In the Matter of)	
)	
VERDE DITCH COMPANY AND)	No. 4772
LOWER VERDE DITCH COMPANY.)	
)	PETITION FOR APPROVAL OF
)	DRAINAGE DESIGN AND
)	MODIFICATION TO VERDE DITCH

DRAINAGE DESIGN

THE ARBOR

Verde Ditch Bank Design

PLATE II

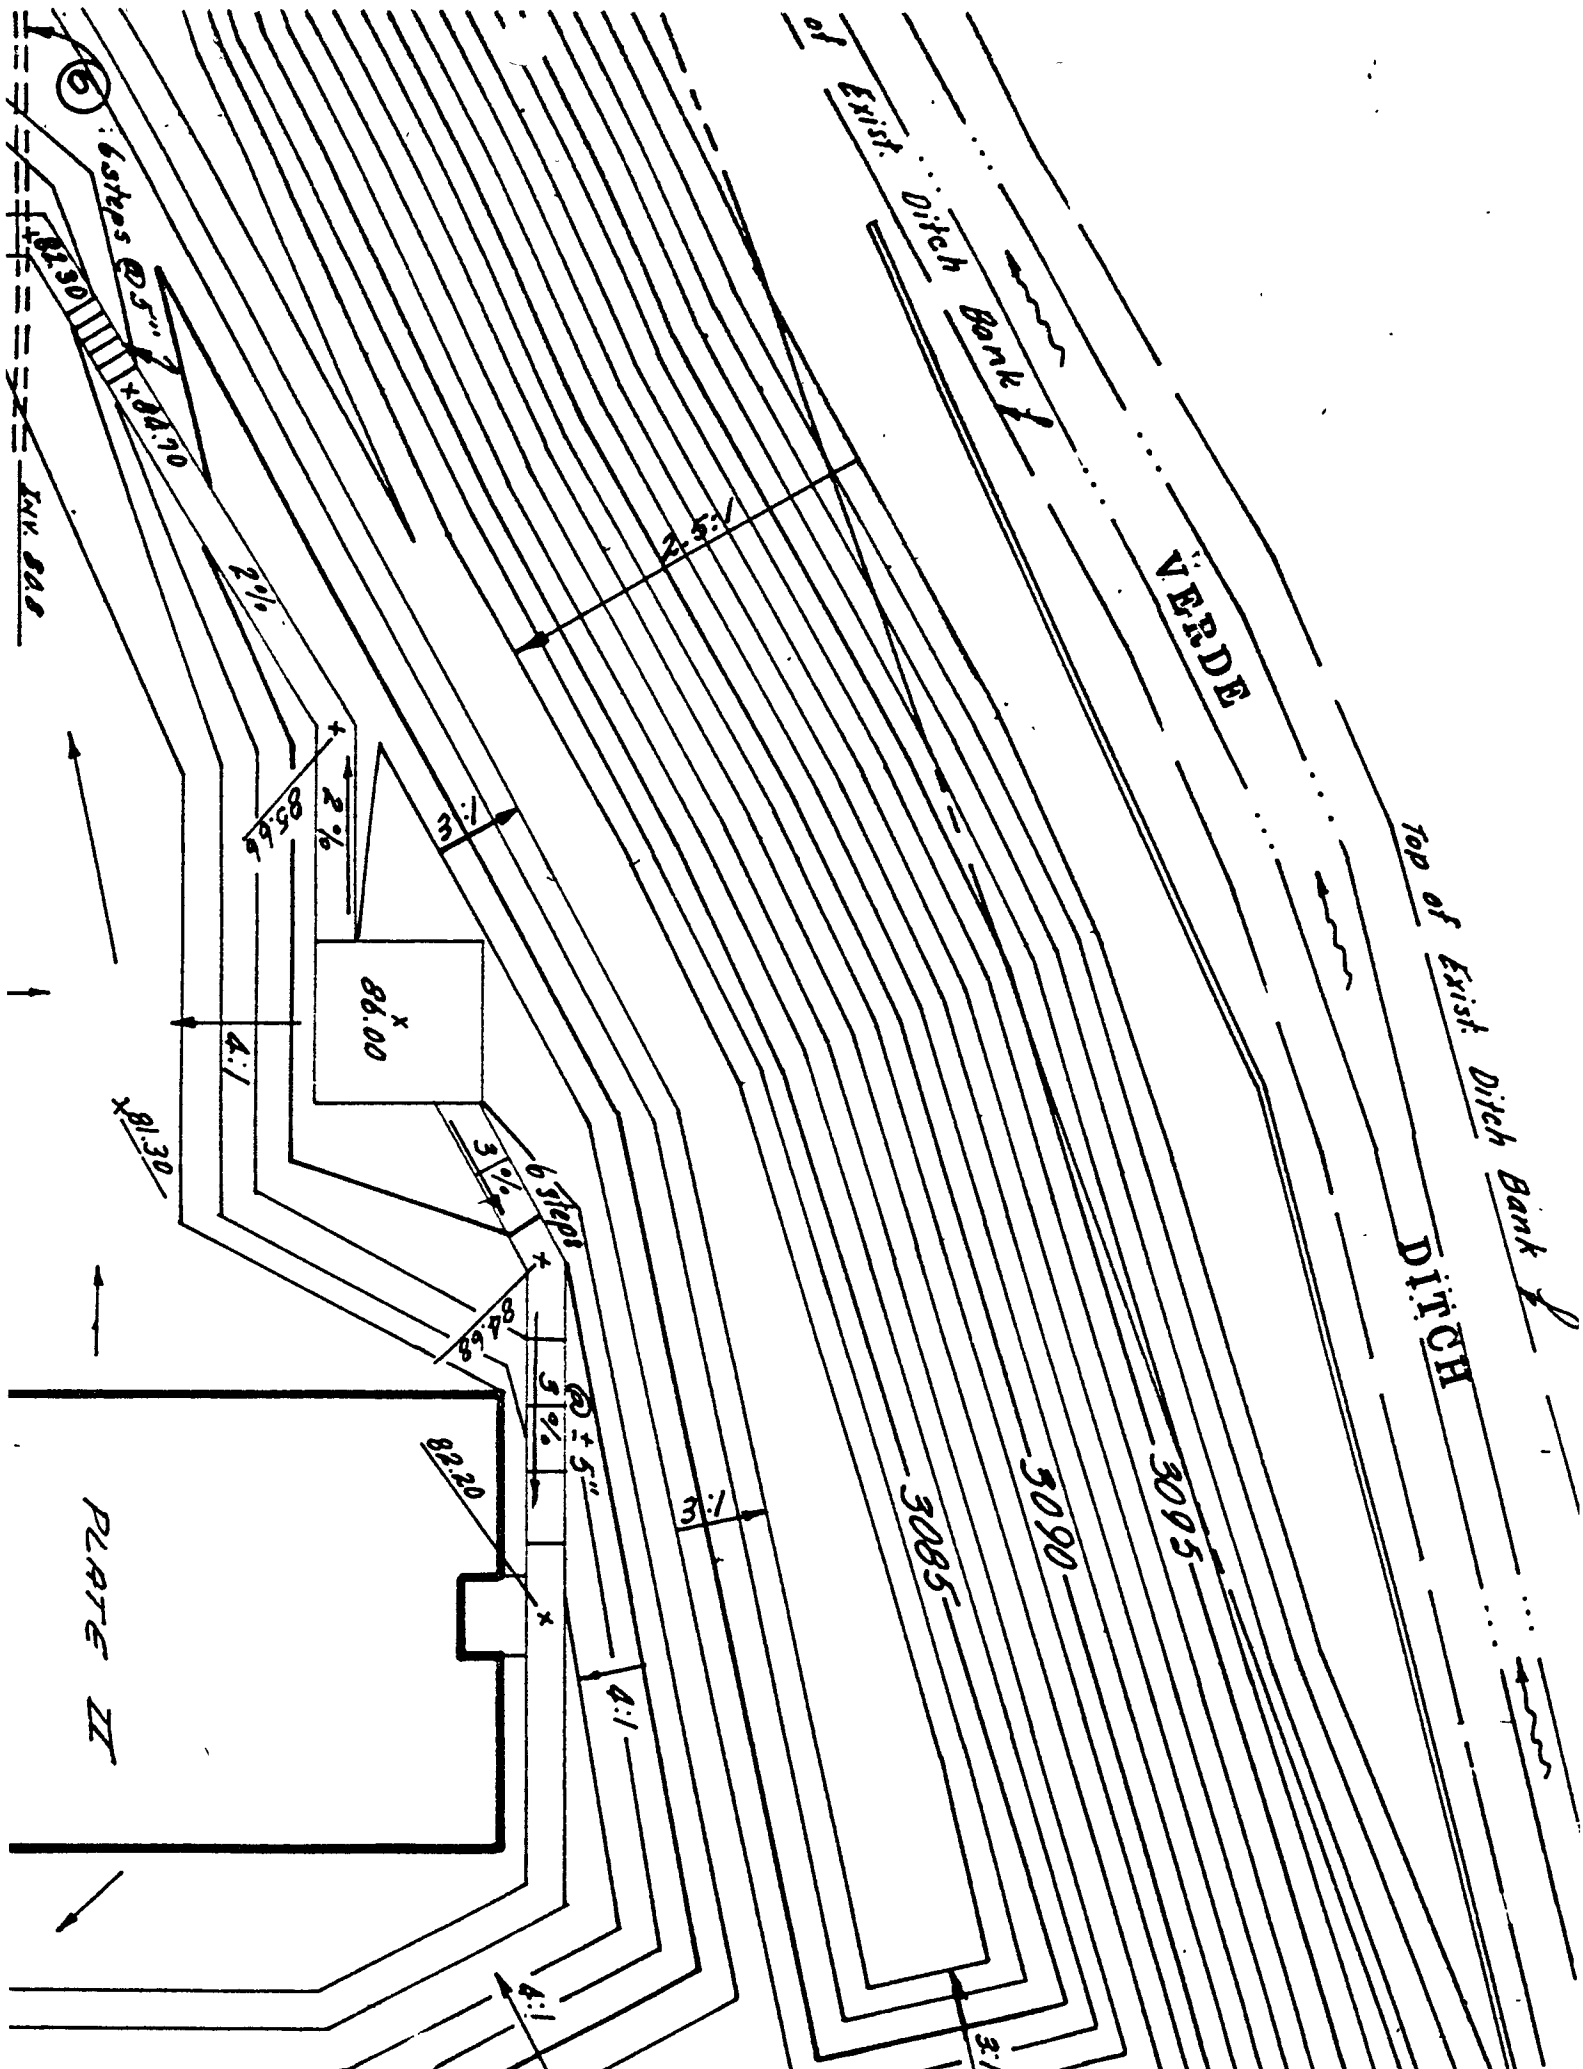
The south ditch bank crest width was increased from an average width of 7 feet to 15 feet with a 2.5:1 negative slope toward a storm water swale immediately north of the building site -- see Plate II. This swale at its critical points, carries the same water cross-sectional area as the Verde Ditch. The horizontal distance from the ditch bottom to bank slope will be increased from 20 feet to 35 feet.

PLATE III

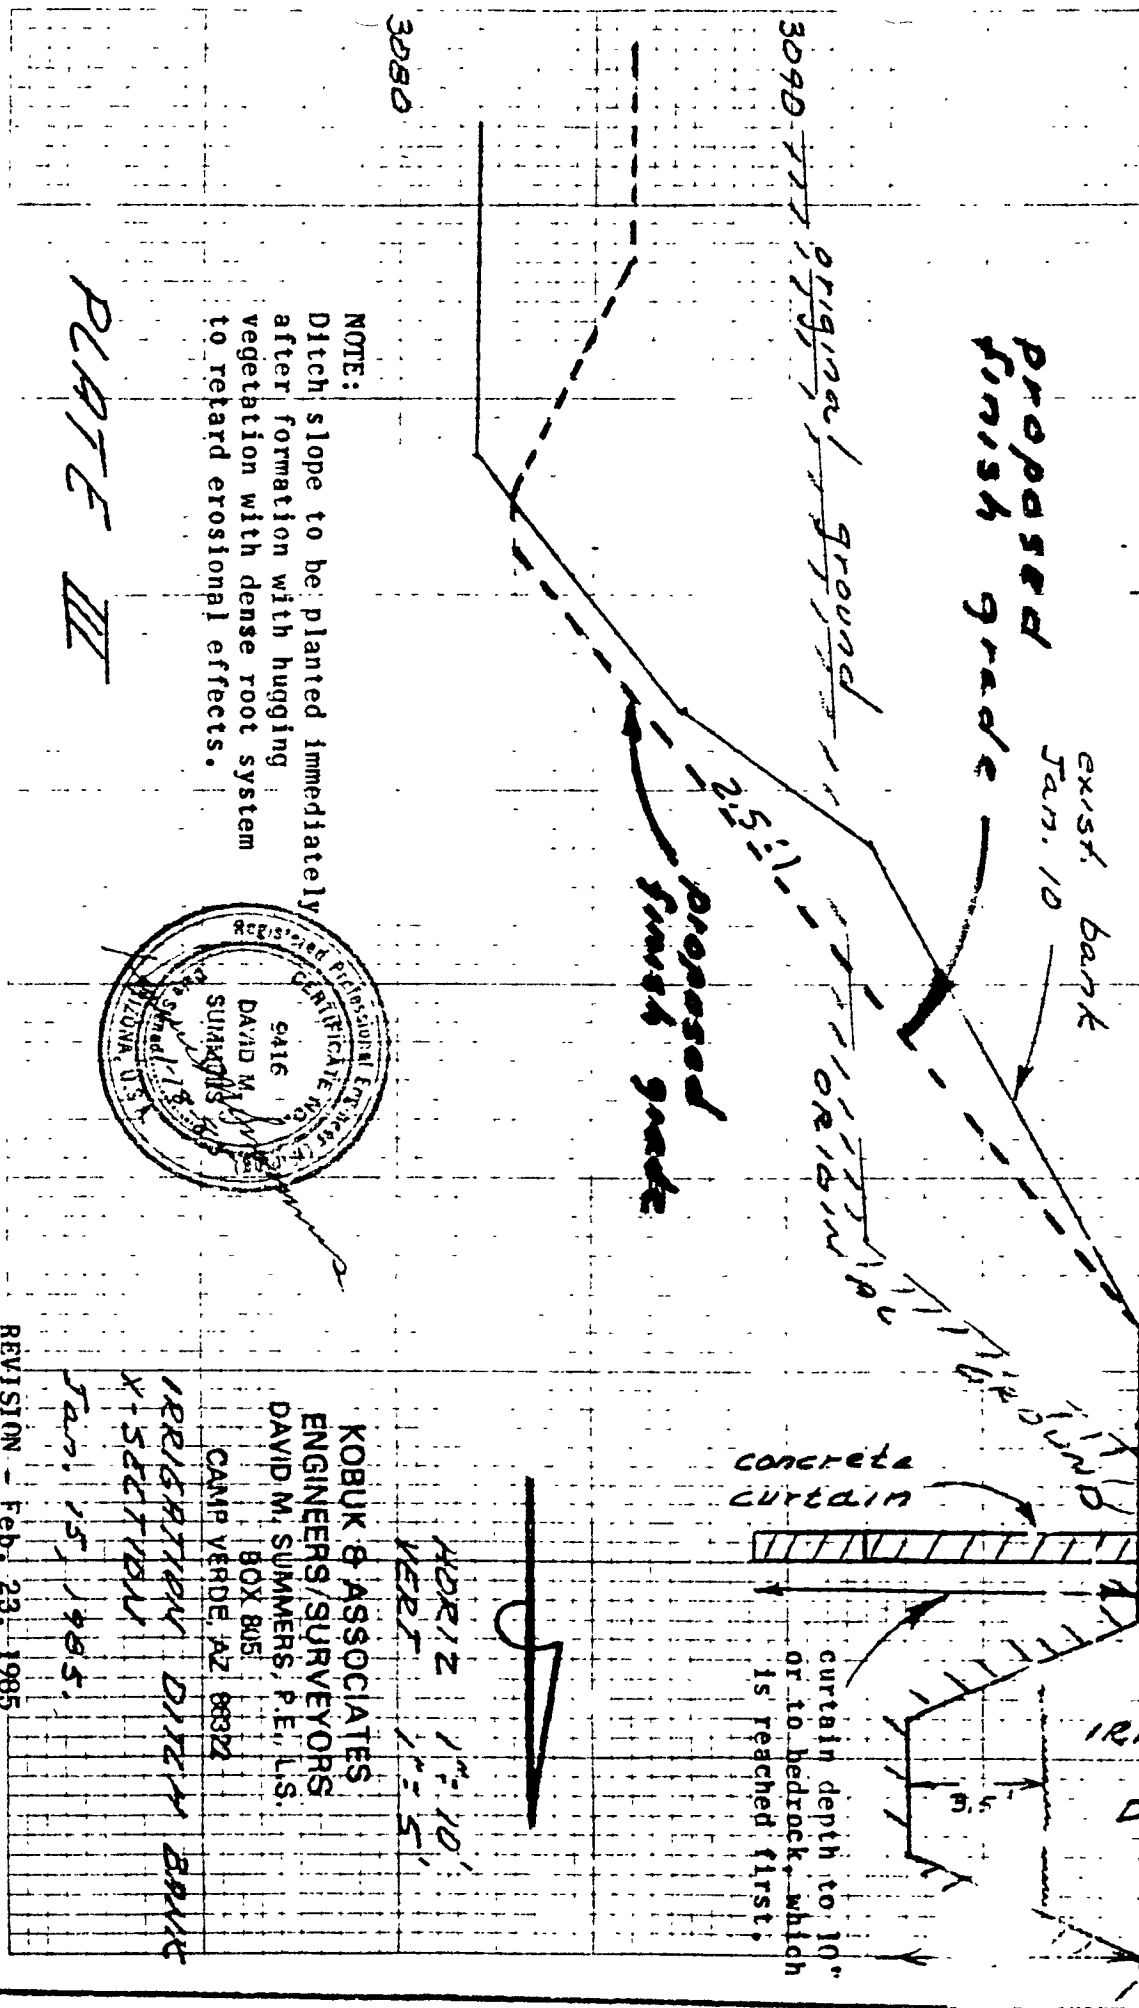
A 200-foot concrete curtain will be installed along the ditch bank to a depth at least one foot below the ditch bottom -- See Plate III. This interior wall is a membrane to prevent any complete bank penetration.

NOTE:
Curtain to be placed as close to the ditch as is feasible without disturbing the inside ditch wall. Note to be closer than 4".

NOTE:
Ditch slope to be planted immediately after formation with hugging vegetation with dense root system to retard erosional effects.
